Submission to NSW Planning and Environment

Sydney Metro - Blues Point Temporary Retrieval Site

1. **Name:-** Judith Rintoul, 60 Blues Point Road, McMahon's Point NSW 2060
2. **Application name:** Mitigation of impact at the proposed Blues Point Retrieval Site

3. **Application number:-** SS1 15_7400
4. **Brief Statement of Objection:** - I object to the proposal to excavate Blues Point Reserve for a Metro Retrieval Site on the grounds of

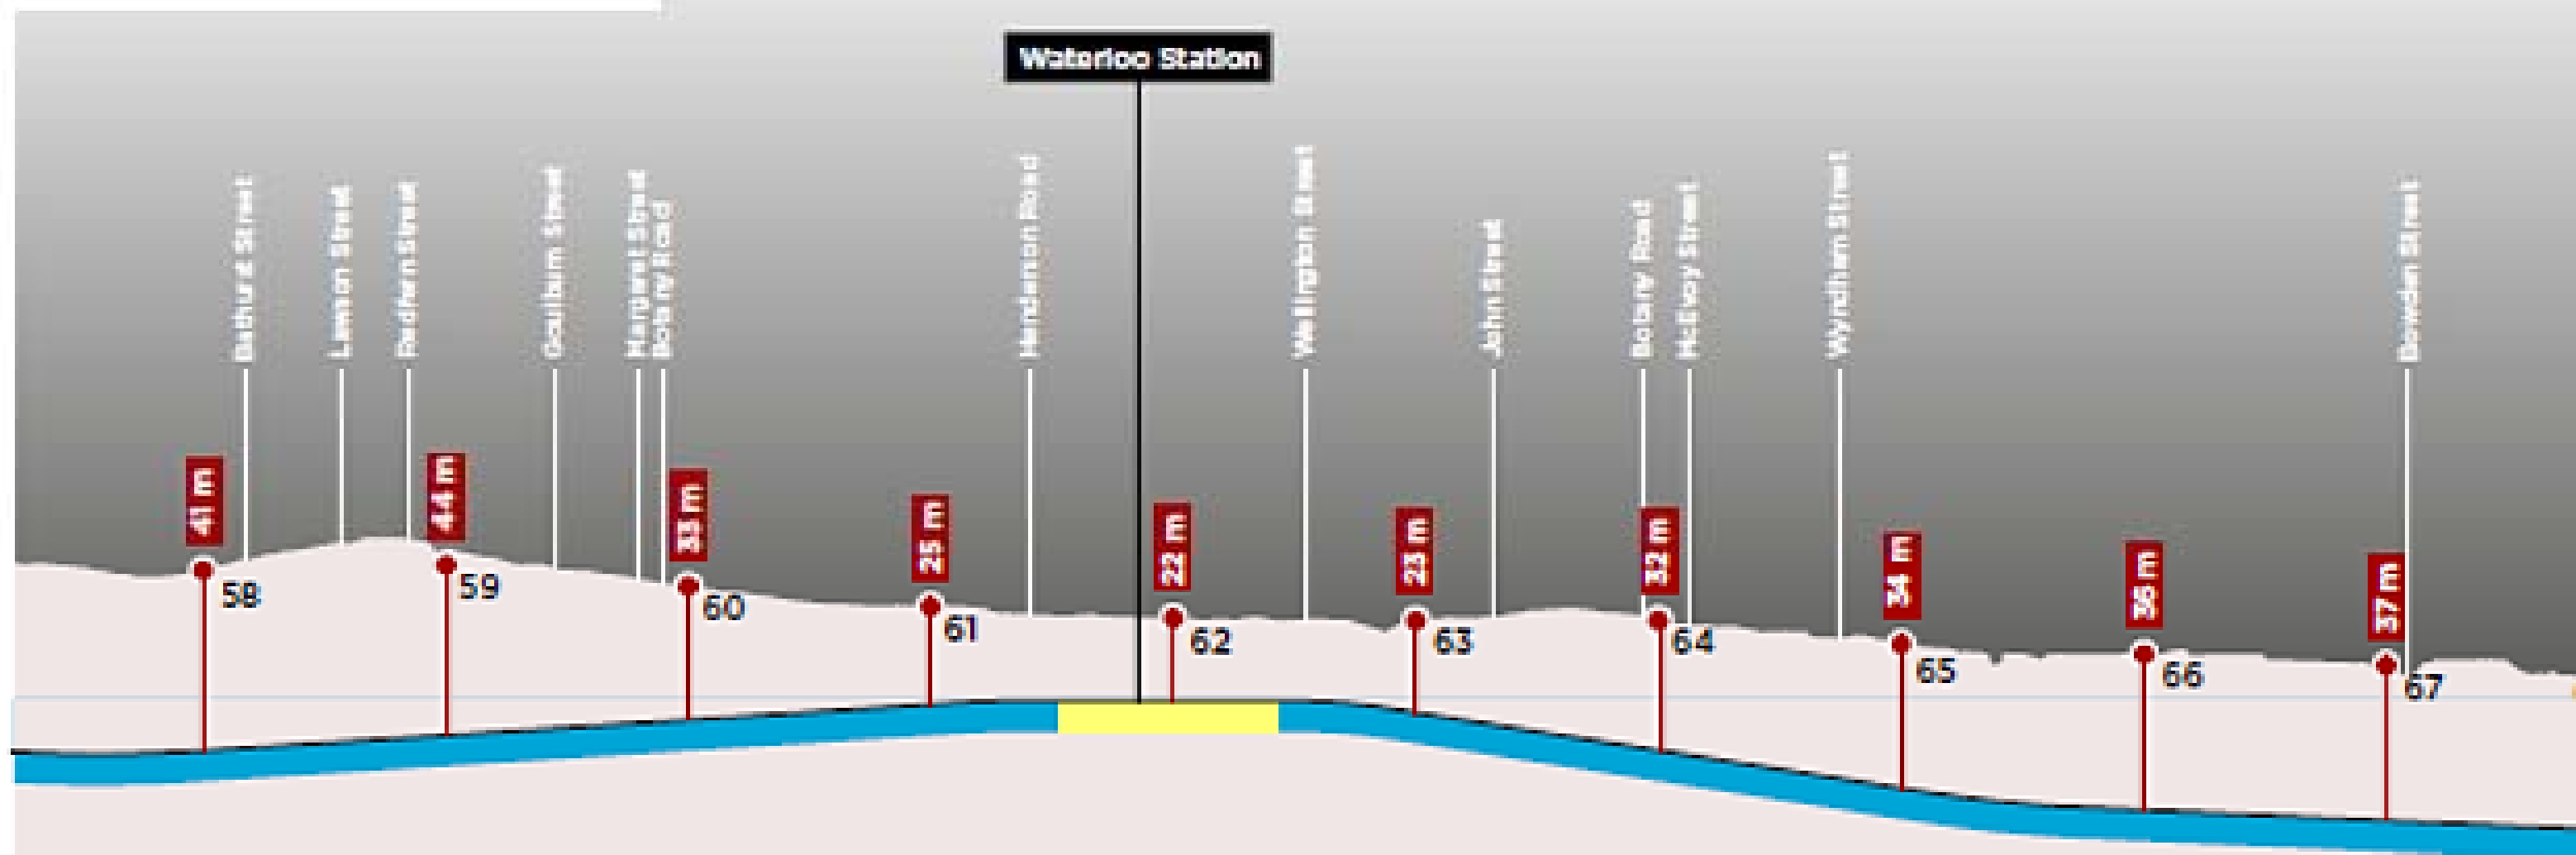
In this location it is only proposed to have "standard attenuation" in one direction and "high attenuation" in another. As both tracks run under the same buildings I am not sure why they have different attenuation methods.

This is concerning because immediately above this section is medium density residential development. At this depth there is no doubt that vibration from the operating trains will be felt and cause noise disturbance and possibly structural damage. I can feel the vibration from the Airport line which is some distance away on George Street.

Due to the shallow depth of the proposed tunnel and the medium density residential use directly above, this section of the track must have "very high attenuation" to avoid negative impacts to the residents. Anything less would be simply cost cutting at the expense of the existing residents.

Should the very high attenuation be implemented in this location, I would support the proposal.

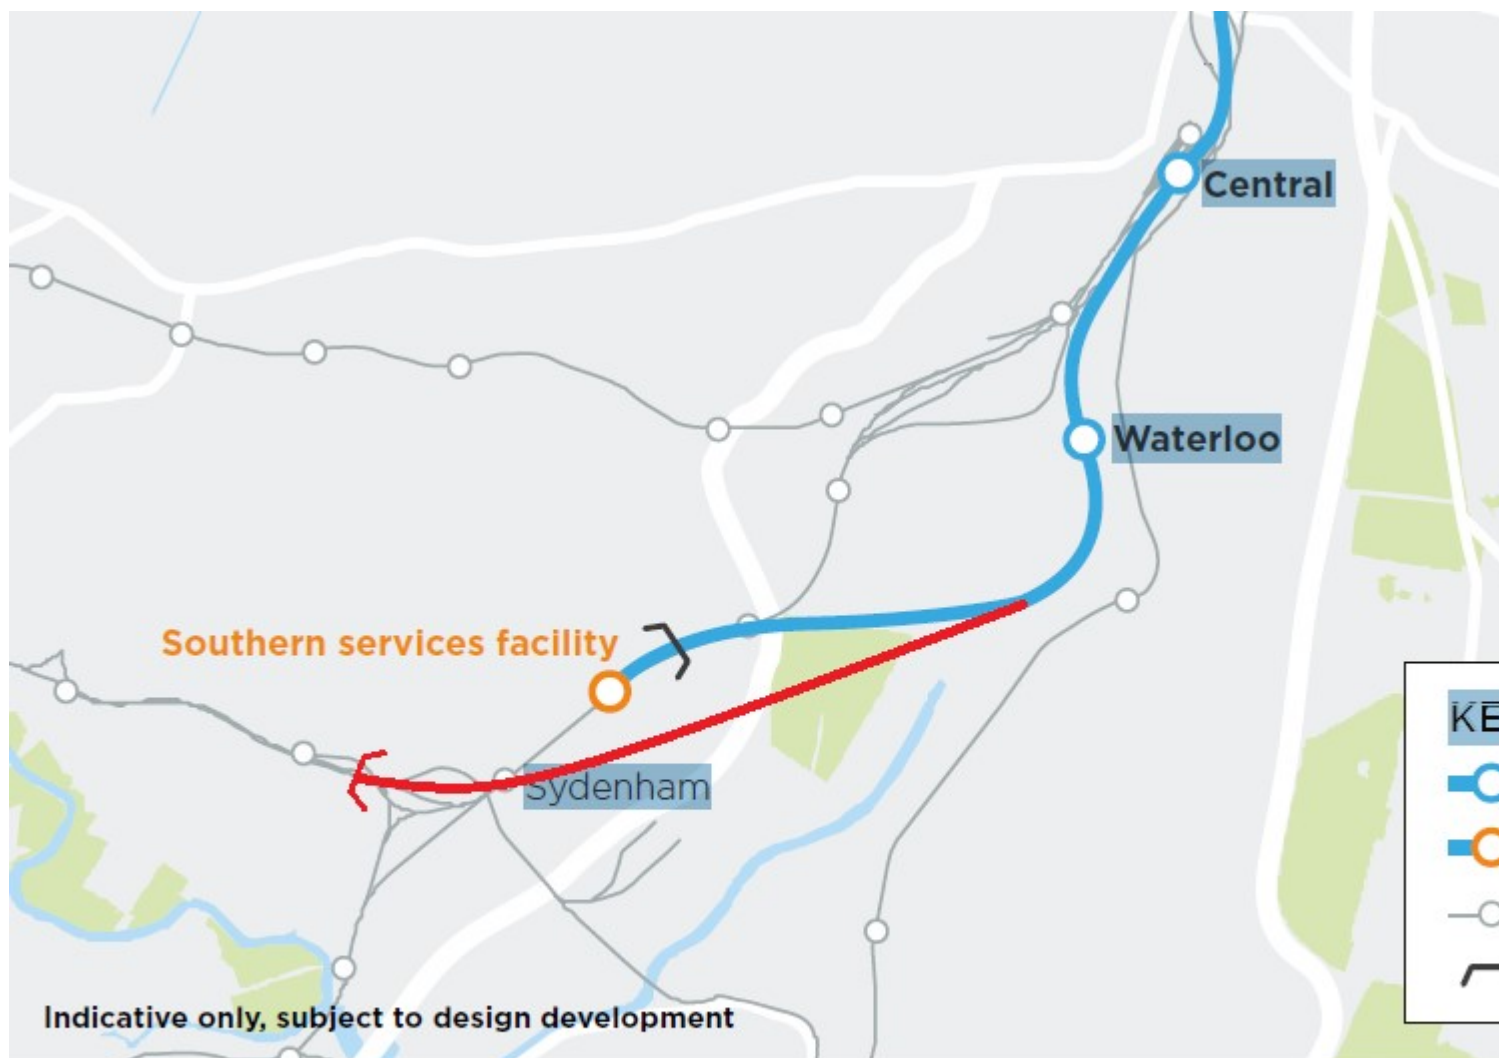
Ultimately Sydney Trains will require at least one additional track, probably two between Erskineville and Sydenham to maximise the capacity for South and Illawarra express services, while meeting CountryLink's needs too (this will still hold, albeit delayed, if the metro is extended to Hurstville). It means all six Sydenham platforms will be required for Sydney Trains.

My attached diagram suggests an alternate alignment: heading south from Waterloo, keep to the east of the proposed alignment, build an underground station at Sydenham with a dive immediately west of Sydenham station. While this adds the expense of additional tunneling and a further underground station, the complexities of overlaying existing infrastructure at Sydenham is eliminated should have significant offsets. It also maintains greater flexibility for Sydney Trains.
